Memorandum: Fairway Estates Phase II PUD/Subdivision Application

Date: 09/22/2022
To: City of Florence, Planning Department
From: Metro Planning, Inc.
Subject: Completeness Comments for PC 21 39 SUB 03 & PC 21 40 PUD 02

Date: January 10, 2023
To: City of Florence, Planning Department
From: Metro Planning, Inc.
Subject: Substantive Comments for PC 21 39 SUB 03 & PC 21 40 PUD 02

Date: April 25, 2023
To: City of Florence, Planning Department
From: Metro Planning, Inc.
Subject: Substantive Comments for PC 21 39 SUB 03 & PC 21 40 PUD 02
Fee-In-Lieu OpenSpace

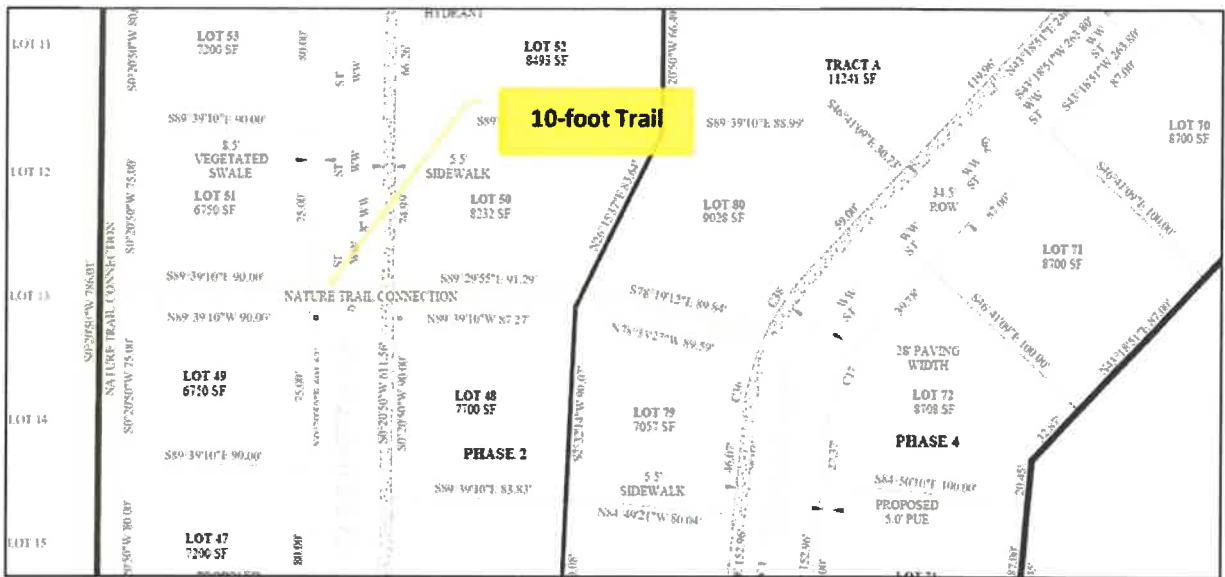
In support of the purpose of FCC 10-36-2-10, applicant proposes a nature trail near the middle of a block in-lieu-of a street connection and also seeks Planning Commission consideration with a request for exception/modification to block length requirement. (Please see written statements below under FCC 11-7 that address exception/modification criteria.)

Please see attached Plans for more detail³. Please see illustrations of Nature Trail Connection on Revised Utility Map below.
